ACCESSIBILITY ASSESSMENT

ADA TITLE II ASSESSMENT

Central Gardens
6804 Central Avenue
Pepper Mill Village, Maryland 20743

June 23, 2021

Map for Barrier ID: AX239672

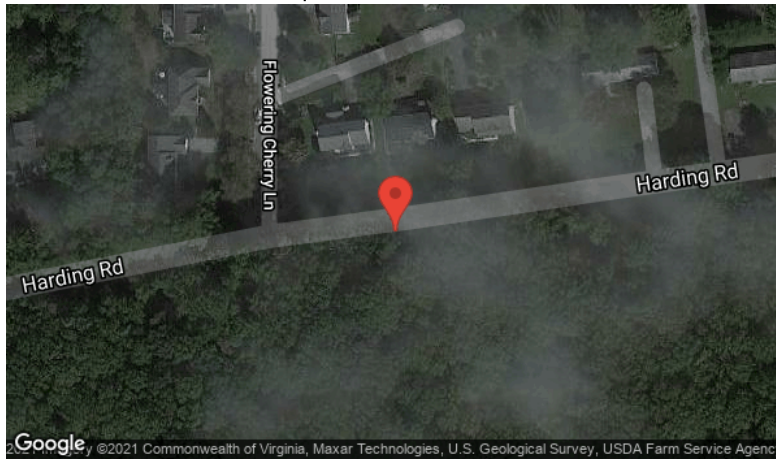
Assembly	Entrance to Building
Type	Building Entrance-Door
ADA Standard	305.2; 404.2
Barrier Detail	The maneuvering clearance at the accessible door is not level and clear.
Location Description	6800-Building Entrance Door
Observed	May 28, 2021 by Lloyd.fojas@bureauveritas.com

For a front approach on the pull side the maneuvering clearance has a 6-1/2" vertical change at the face of the door.

Remove and replace the surface within the required maneuvering clearance area so that the surface is level and clear with maximum slope 1:48 (2.08%) in any direction. The required depth of the maneuvering clearance is 60" minimum. The required side clearance is 18" minimum on the latch side of the door. Maneuvering clearance shall extend the full width of the doorway and the required latch side clearance. Floor or ground space within the required maneuvering clearance shall be maximum 1:48 (2.08%) slope. Changes in level are not permitted.

Map for Barrier ID: AX239669

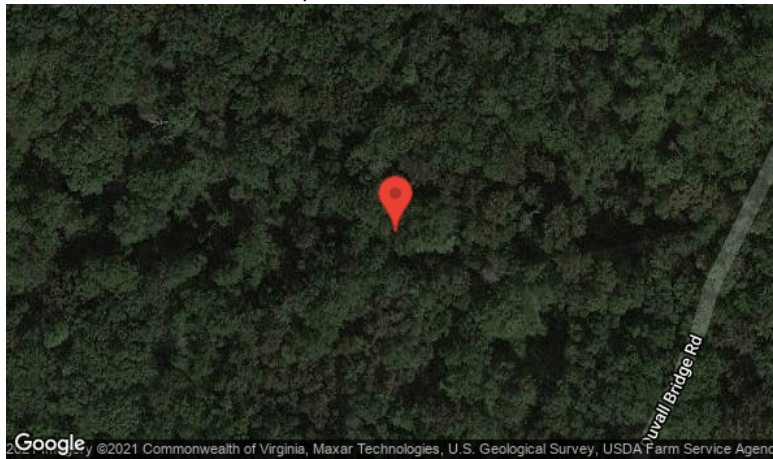
Assembly	Entrance to Building
Type	Building Entrance-Door
ADA Standard	305.2; 404.2
Barrier Detail	The maneuvering clearance at the accessible door is not level and clear.
Location Description	6802-Building Entrance Door
Observed	May 28, 2021 by Lloyd.fojas@bureauveritas.com

For a front approach on the pull side the maneuvering clearance has a 6-1/2" vertical change at the face of the door.

Remove and replace the surface within the required maneuvering clearance area so that the surface is level and clear with maximum slope 1:48 (2.08%) in any direction. The required depth of the maneuvering clearance is 60" minimum. The required side clearance is 18" minimum on the latch side of the door. Maneuvering clearance shall extend the full width of the doorway and the required latch side clearance. Floor or ground space within the required maneuvering clearance shall be maximum 1:48 (2.08%) slope. Changes in level are not permitted.

Map for Barrier ID: AX239670

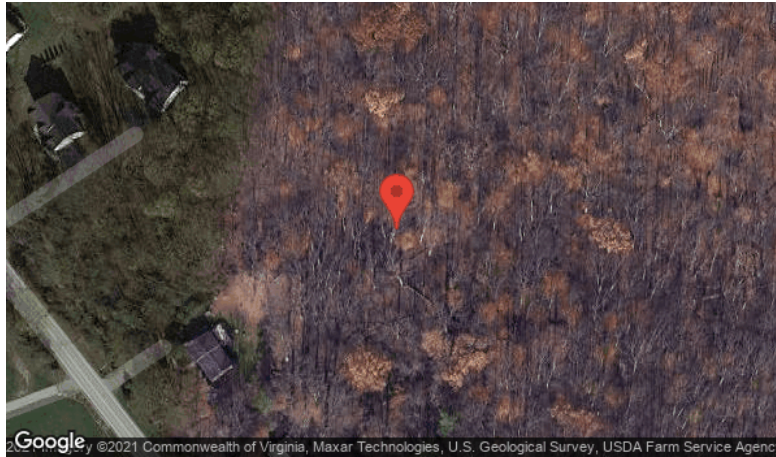
Assembly	Entrance to Building
Type	Building Entrance-Door
ADA Standard	305.2; 404.2
Barrier Detail	The maneuvering clearance at the accessible door is not level and clear.
Location Description	6804-Building Entrance Door
Observed	May 28, 2021 by Lloyd.fojas@bureauveritas.com

For a front approach on the pull side the maneuvering clearance has a 7" vertical change at the face of the door.

Remove and replace the surface within the required maneuvering clearance area so that the surface is level and clear with maximum slope 1:48 (2.08%) in any direction. The required depth of the maneuvering clearance is 60" minimum. The required side clearance is 18" minimum on the latch side of the door. Maneuvering clearance shall extend the full width of the doorway and the required latch side clearance. Floor or ground space within the required maneuvering clearance shall be maximum 1:48 (2.08%) slope. Changes in level are not permitted.

Map for Barrier ID: AX240224

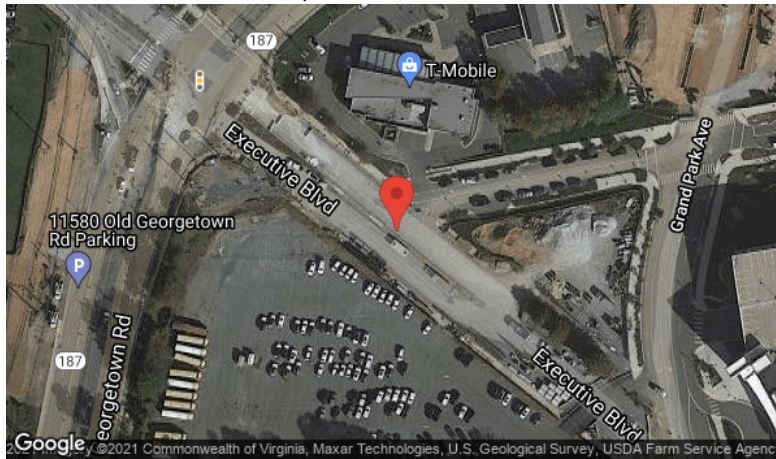
Assembly	Entrance to Building
Type	Building Entrance-Door
ADA Standard	305.2; 404.2
Barrier Detail	The maneuvering clearance at the accessible door is not level and clear.
Location Description	6812-Building Entrance Door
Observed	May 28, 2021 by Lloyd.fojas@bureauveritas.com

For a front approach on the pull side the maneuvering clearance has a 7-1/2" vertical change at the face of the door.

Remove and replace the surface within the required maneuvering clearance area so that the surface is level and clear with maximum slope 1:48 (2.08%) in any direction. The required depth of the maneuvering clearance is 60" minimum. The required side clearance is 18" minimum on the latch side of the door. Maneuvering clearance shall extend the full width of the doorway and the required latch side clearance. Floor or ground space within the required maneuvering clearance shall be maximum 1:48 (2.08%) slope. Changes in level are not permitted.

Map for Barrier ID: AX240316

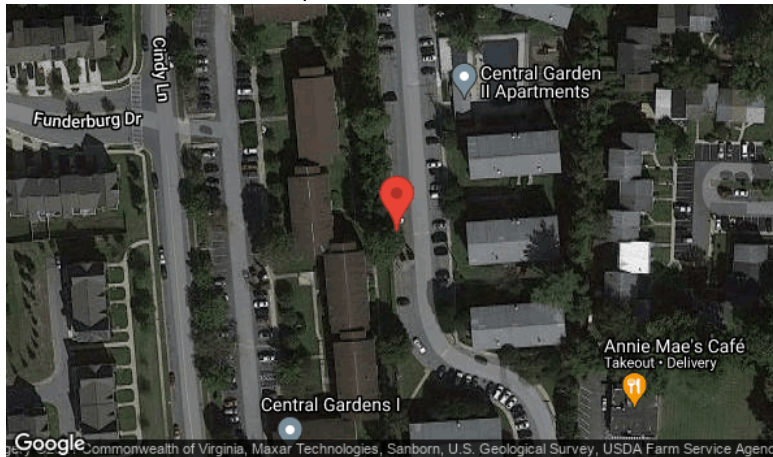
Assembly	Accessible Parking
Type	Parking Space-Van
ADA Standard	502.4, State of MD 05.07.C (2)(d)
Barrier Detail	MARYLAND: The access aisle slope is greater than 1:50 (2%).
Location Description	Access Aisle at Accessible Parking Space P1-A and P1-B
Observed	May 28, 2021 by Lloyd.fojas@bureauveritas.com
Site Conditions	The access aisle has a cross slope from 6.5% to 7.4%.

Remove and replace with an adjacent access aisle that is at least 96" wide and has a slope of maximum 1:50 (2%) in all directions. [EXCEPTION: Slopes not steeper than 1:48 (2.08%) shall be permitted.] Parking spaces and access aisles serving them shall be compliant. Changes in level are not permitted. Access aisles shall be at the same level as the parking spaces they serve. Measurements shall be made to the centerline of the stripe. [EXCEPTION: Where accessible stalls and aisles are not adjacent to another stall or aisle, measurements shall be permitted to include the full width of the line defining the accessible parking space or aisle.] The quantity and order of magnitude cost estimate provided for this barrier are limited to the extent of the area identified as non-compliant. Additional costs that may be associated with removal of the barrier are not included.

Map for Barrier ID: AX240317

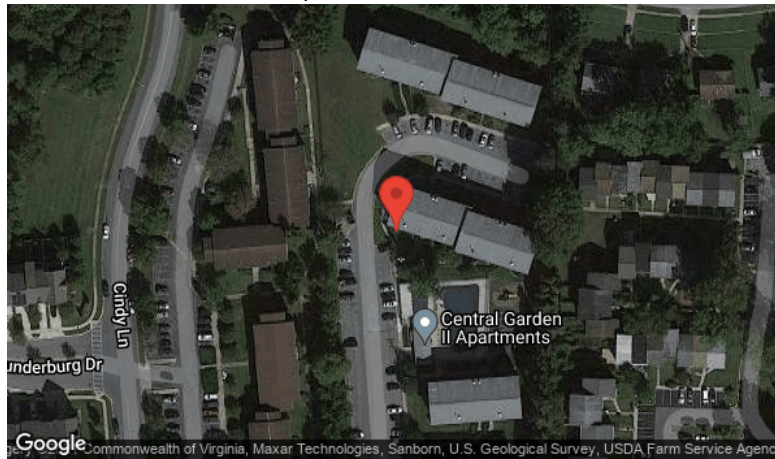
Assembly	Accessible Parking
Type	Parking Space-Van
ADA Standard	502.4, State of MD 05.07.C (2)(d)
Barrier Detail	MARYLAND: The access aisle slope is greater than 1:50 (2%).
Location Description	Access Aisle at Accessible Parking Space P1-E
Observed	May 28, 2021 by Lloyd.fojas@bureauveritas.com
Site Conditions	The van access aisle has a cross slope of 4.1% to 5.2%.

Remove and replace with an adjacent access aisle that is at least 96" wide and has a slope of maximum 1:50 (2%) in all directions. [EXCEPTION: Slopes not steeper than 1:48 (2.08%) shall be permitted.] Parking spaces and access aisles serving them shall be compliant. Changes in level are not permitted. Access aisles shall be at the same level as the parking spaces they serve. Measurements shall be made to the centerline of the stripe. [EXCEPTION: Where accessible stalls and aisles are not adjacent to another stall or aisle, measurements shall be permitted to include the full width of the line defining the accessible parking space or aisle.] The quantity and order of magnitude cost estimate provided for this barrier are limited to the extent of the area identified as non-compliant. Additional costs that may be associated with removal of the barrier are not included.

Map for Barrier ID: AX240315

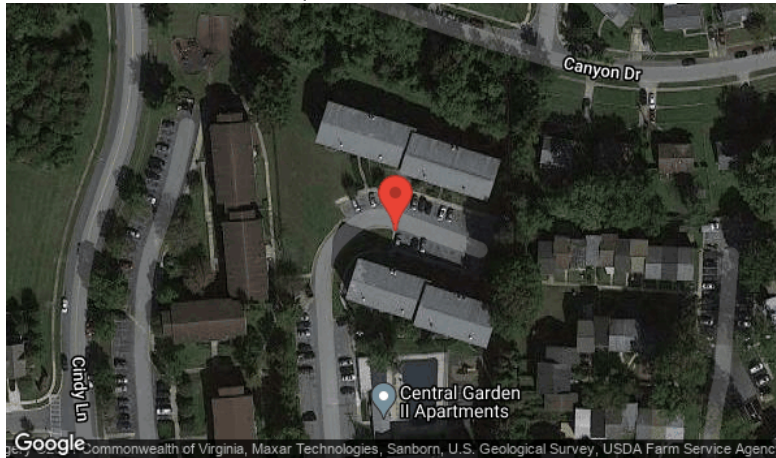
Assembly	Accessible Parking
Type	Parking Space-Car
ADA Standard	502.4
Barrier Detail	The access aisle slope is greater than 1:50 (2%).
Location Description	Access Aisle at Accessible Parking Space P1-G and P1-H
Observed	May 28, 2021 by Lloyd.fojas@bureauveritas.com
Site Conditions	The access aisle has a cross slope of 4.2%.

Remove and replace with an adjacent access aisle that is at least 60" wide and has a slope of maximum 1:50 (2%) in all directions. [EXCEPTION: Slopes not steeper than 1:48 (2.08%) shall be permitted.] Changes in level are not permitted. Parking spaces and access aisles serving them shall be compliant. Access aisles shall be at the same level as the parking spaces they serve. Width measurements shall be made from the centerline of the markings. [EXCEPTION: Where parking spaces or access aisles are not adjacent to another parking space or access aisle, measurements shall be permitted to include the full width of the line defining the parking space or access aisle.] The quantity and order of magnitude cost estimate provided for this barrier are limited to the extent of the area identified as non-compliant. Additional costs that may be associated with removal of the barrier are not included.

Map for Barrier ID: AX240322

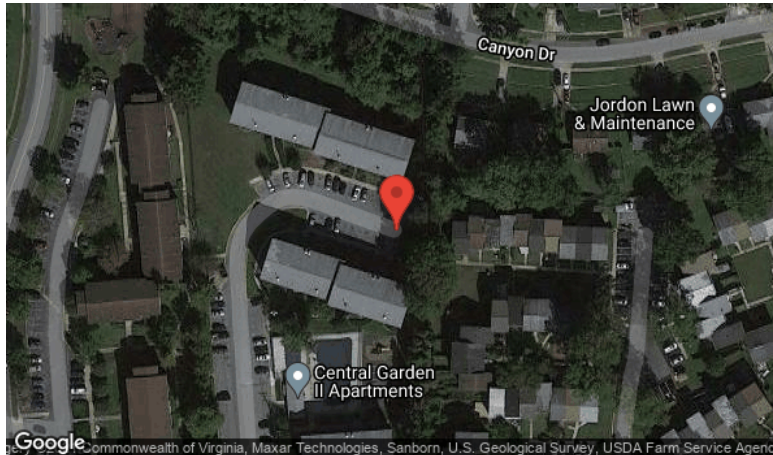
Assembly	Accessible Parking
Type	Parking Space-Car
ADA Standard	502.1, 502.2
Barrier Detail	Accessible car aisle markings do not define the aisle width.
Location Description	Access Aisle at Accessible Parking Space P1-G and P1-H
Observed	May 28, 2021 by Lloyd.fojas@bureauveritas.com
Site Conditions	The access aisle markings are faded.

Repaint car aisle markings. Accessible car stalls shall be 96" wide minimum, shall be marked to define the width, and shall have an adjacent access aisle, minimum 60" wide. Width measurements of parking spaces and access aisles shall be made from the centerline of the markings. [EXCEPTION: Where parking spaces or access aisles are not adjacent to another parking space or access aisle, measurements shall be permitted to include the full width of the line defining the parking space or access aisle.] NOTE: State and local codes may require alternate dimensions, and may also specify the method and color of markings.

Map for Barrier ID: AX239568

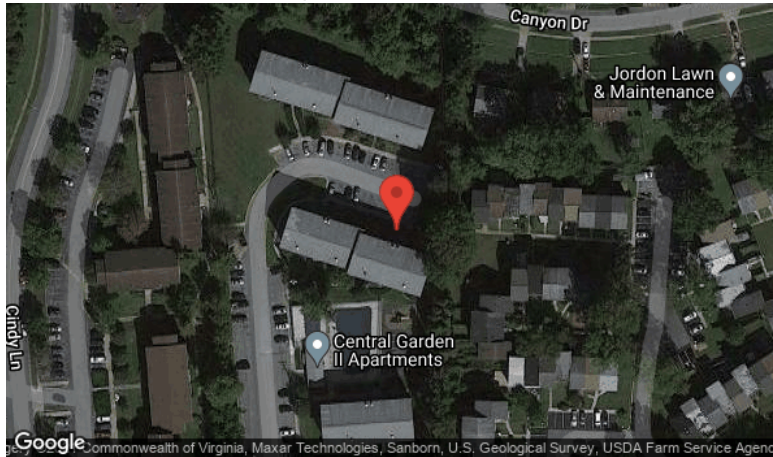
Assembly	Exterior Access Route
Type	Parking Space-Van
ADA Standard	502.4, State of MD 05.07.C (2)(d)
Barrier Detail	MARYLAND: The access aisle slope is greater than 1:50 (2%).
Location Description	Access Aisle at Accessible Parking Space P1-I
Observed	May 28, 2021 by Lloyd.fojas@bureauveritas.com

The van access aisle has a cross slope of 4.7% and a 5/8" to 1-1/2" vertical change at the curb ramp.

Remove and replace with an adjacent access aisle that is at least 96" wide and has a slope of maximum 1:50 (2%) in all directions. [EXCEPTION: Slopes not steeper than 1:48 (2.08%) shall be permitted.] Parking spaces and access aisles serving them shall be compliant. Changes in level are not permitted. Access aisles shall be at the same level as the parking spaces they serve. Measurements shall be made to the centerline of the stripe. [EXCEPTION: Where accessible stalls and aisles are not adjacent to another stall or aisle, measurements shall be permitted to include the full width of the line defining the accessible parking space or aisle.] The quantity and order of magnitude cost estimate provided for this barrier are limited to the extent of the area identified as non-compliant. Additional costs that may be associated with removal of the barrier are not included.

Map for Barrier ID: AX239619

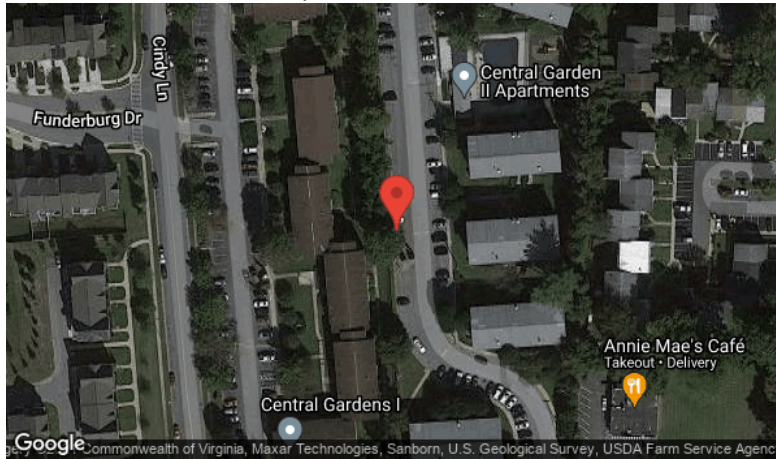
Assembly	Accessible Parking
Type	Parking Space-Van
ADA Standard	502.4
Barrier Detail	The parking space slope is greater than 1:50 (2%).
Location Description	Accessible Parking Space P1-A and P1-B
Observed	May 28, 2021 by Lloyd.fojas@bureauveritas.com

Remove and replace with a van space which has a slope of maximum 1:50 (2%) in all directions. [EXCEPTION: Slopes not steeper than 1:48 (2.08%) shall be permitted.] Changes in level are not permitted. Parking spaces and access aisles serving them shall be compliant. Width measurements shall be made from the centerline of the markings. [EXCEPTION: Where parking spaces or access aisles are not adjacent to another parking space or access aisle, measurements shall be permitted to include the full width of the line defining the parking space or access aisle.] The quantity and order of magnitude cost estimate provided for this barrier are limited to the extent of the area identified as non-compliant. Additional costs that may be associated with removal of the barrier are not included.

Map for Barrier ID: AX239626

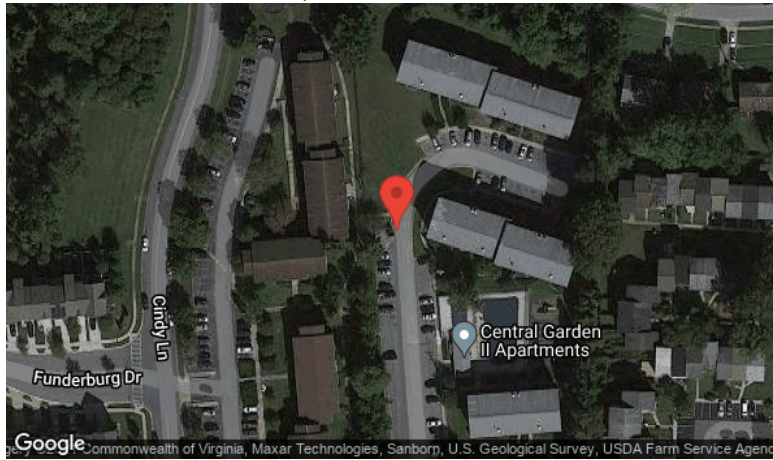
Assembly	Accessible Parking
Type	Parking Space-Car
ADA Standard	502.4
Barrier Detail	The slope of the parking space is greater than 1:50 (2%).
Location Description	Accessible Parking Space P1-C
Observed	May 28, 2021 by Lloyd.fojas@bureauveritas.com
Site Conditions	The accessible parking space has a cross slope of 9.7%

Remove and replace with a parking space that has no more than 1:50 (2%) slope in all directions. [EXCEPTION: Slopes not steeper than 1:48 (2.08%) shall be permitted.] Changes in level are not permitted. Parking spaces and access aisles shall be level with surface slopes not exceeding 1:50 in all directions. Parking spaces and access aisles serving them shall be compliant. Access aisles shall be at the same level as the parking spaces they serve. The quantity and order of magnitude cost estimate provided for this barrier are limited to the extent of the area identified as non-compliant. Additional costs that may be associated with removal of the barrier are not included.

Map for Barrier ID: AX240319

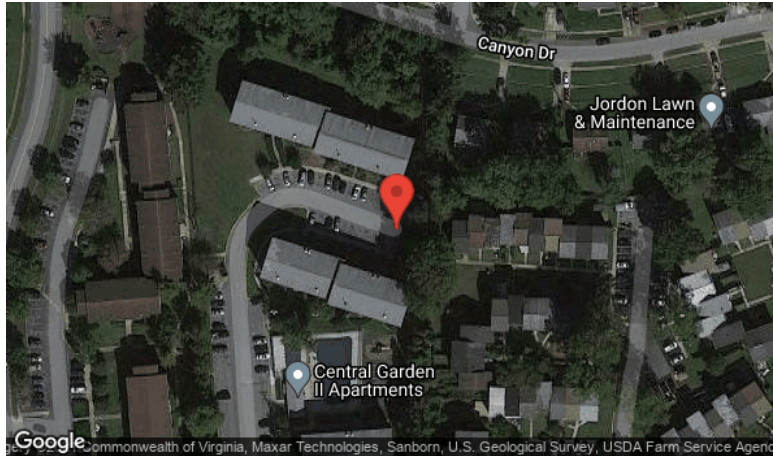
Assembly	Accessible Parking
Type	Parking Space-Car
ADA Standard	502.3; 502.4; 502.5
Barrier Detail	An access aisle is not provided.
Location Description	Accessible Parking Space P1-C, P1-D, and P1-H
Observed	May 28, 2021 by Lloyd.fojas@bureauveritas.com

Re-stripe and add an adjacent access aisle that is at least 60" wide and has a slope of maximum 1:48 (2.08%) in all directions. Width measurements shall be made from the centerline of the markings. [EXCEPTION: Where parking spaces or access aisles are not adjacent to another parking space or access aisle, measurements shall be permitted to include the full width of the line defining the parking space or access aisle.] Access aisles shall adjoin an accessible route. Two parking spaces shall be permitted to share a common access aisle. Accessible routes must connect parking spaces to accessible entrances. In parking facilities where the accessible route must cross vehicular traffic lanes, marked crossings enhance pedestrian safety, particularly for people using wheelchairs and other mobility aids. Where possible, it is preferable that the accessible route not pass behind parked vehicles. Access aisles serving car and van parking spaces shall be 60" wide minimum. Access aisles shall extend the full length of the parking spaces they serve. Access aisles shall be marked so as to discourage parking in them. Access aisles shall not overlap the vehicular way. Access aisles shall be permitted to be placed on either side of the parking space except for angled van parking spaces which shall have access aisles located on the passenger side of the parking spaces. Access aisles shall be at the same level as the parking spaces they serve. Changes in level are not permitted. [EXCEPTION: Slopes not steeper than 1:48 shall be permitted.] Access aisles are required to be nearly level in all directions to provide a surface for wheelchair transfer to and from vehicles. The exception allows sufficient slope for drainage. Built-up curb ramps are not permitted to project into access aisles and parking spaces because they would create slopes greater than 1:48. Parking spaces for vans and access aisles and vehicular routes serving them shall provide a vertical clearance of 98" minimum. Width measurements of parking spaces and access aisles shall be made from the centerline of the markings. Where accessible stalls and aisles are not adjacent to accessible stalls and aisles, measurements shall be permitted to include the full width of the line defining the accessible parking space or aisle.

Map for Barrier ID: AX240067

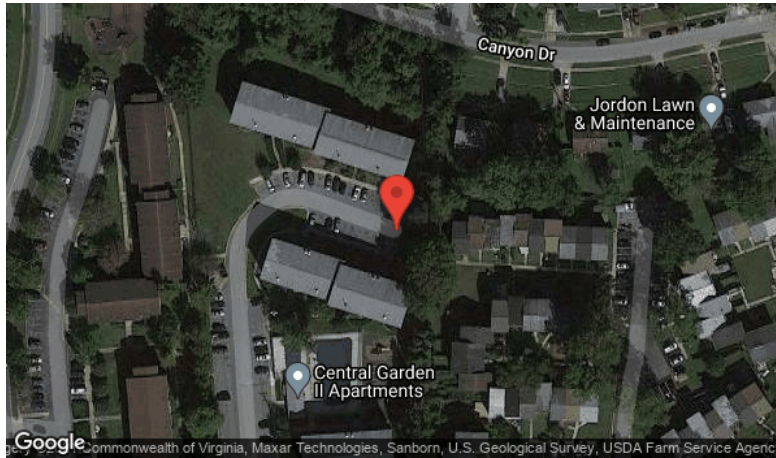
Assembly	Accessible Parking
Type	Parking Space-Car
ADA Standard	502.1, 502.2
Barrier Detail	Accessible car stall markings do not define the stall width.
Location Description	Accessible Parking Space P1-C, P1-D, P1-F, P1-G and P1-H
Observed	May 28, 2021 by Lloyd.fojas@bureauveritas.com
Site Conditions	The accessible parking space markings are faded.

Repaint stall markings. Accessible car stalls shall be 96" wide minimum, shall be marked to define the width, and shall have an adjacent access aisle. Width measurements of parking spaces and access aisles shall be made from the centerline of the markings. [EXCEPTION: Where parking spaces or access aisles are not adjacent to another parking space or access aisle, measurements shall be permitted to include the full width of the line defining the parking space or access aisle.] [NOTE: State and local codes may require alternate dimensions, and may also specify the method and color of markings.]

Map for Barrier ID: AX240313

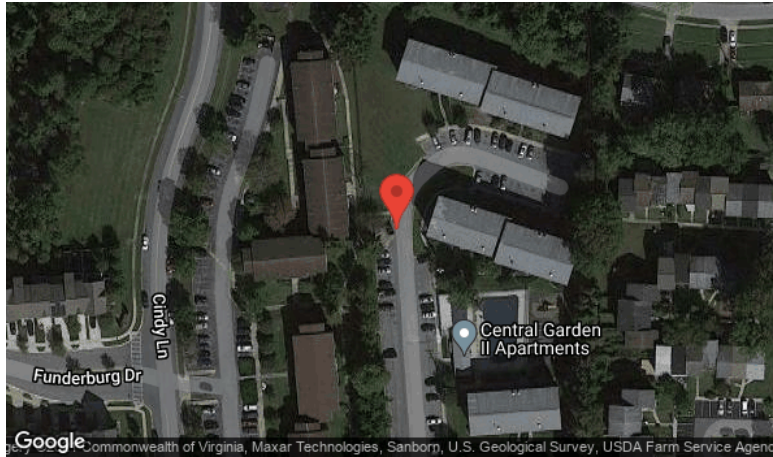
Assembly	Accessible Parking
Type	Parking Space-Car
ADA Standard	State of MD 05.07.D (2)(a)and (b),(3) & (6)
Barrier Detail	MARYLAND: Compliant signage is not provided at the space.
Location Description	Accessible Parking Space P1-D
Observed	May 28, 2021 by Lloyd.fojas@bureauveritas.com
Site Conditions	A sign is not provided at the accessible parking space.

Provide mounted signage showing the International Symbol of Accessibility which is not obscured by a vehicle parked in the space, as well as a reserved parking sign and a maximum fine sign. Parking space identification signs shall include the International Symbol of Accessibility, "RESERVED PARKING" and "MAXIMUM FINE \$xxx" signs. Accessible parking fine amounts vary per county in the State of Maryland. Signs shall be 84" minimum above the stall surface measured to the bottom of the sign OR if flush to/mounted on building or wall, sign should be mounted between 72" and 120" above the stall surface. Where the sign post is mounted on a raised surface which is higher than the stall pavement, the vertical measurement shall be from the stall pavement surface to the bottom of the sign.

Map for Barrier ID: AX239625

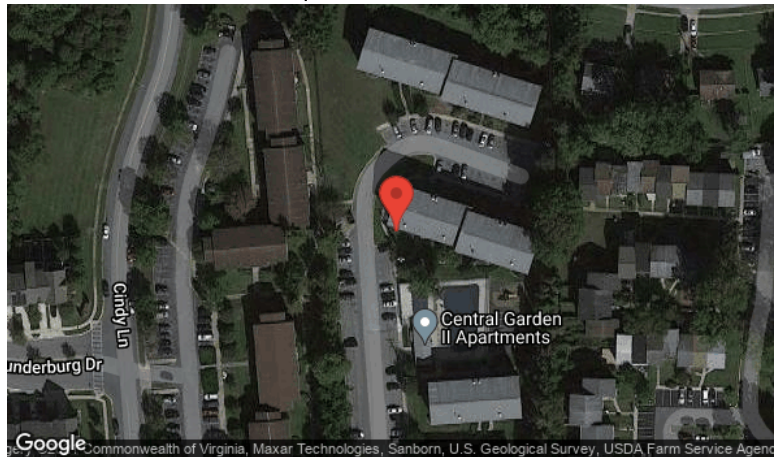
Assembly	Accessible Parking
Type	Parking Space-Van
ADA Standard	502.4
Barrier Detail	The parking space slope is greater than 1:50 (2%).
Location Description	Accessible Parking Space P1-E
Observed	May 28, 2021 by Lloyd.fojas@bureauveritas.com
Site Conditions	The van accessible parking space has a cross slope of 4.1%.

Remove and replace with a van space which has a slope of maximum 1:50 (2%) in all directions. [EXCEPTION: Slopes not steeper than 1:48 (2.08%) shall be permitted.] Changes in level are not permitted. Parking spaces and access aisles serving them shall be compliant. Width measurements shall be made from the centerline of the markings. [EXCEPTION: Where parking spaces or access aisles are not adjacent to another parking space or access aisle, measurements shall be permitted to include the full width of the line defining the parking space or access aisle.] The quantity and order of magnitude cost estimate provided for this barrier are limited to the extent of the area identified as non-compliant. Additional costs that may be associated with removal of the barrier are not included.
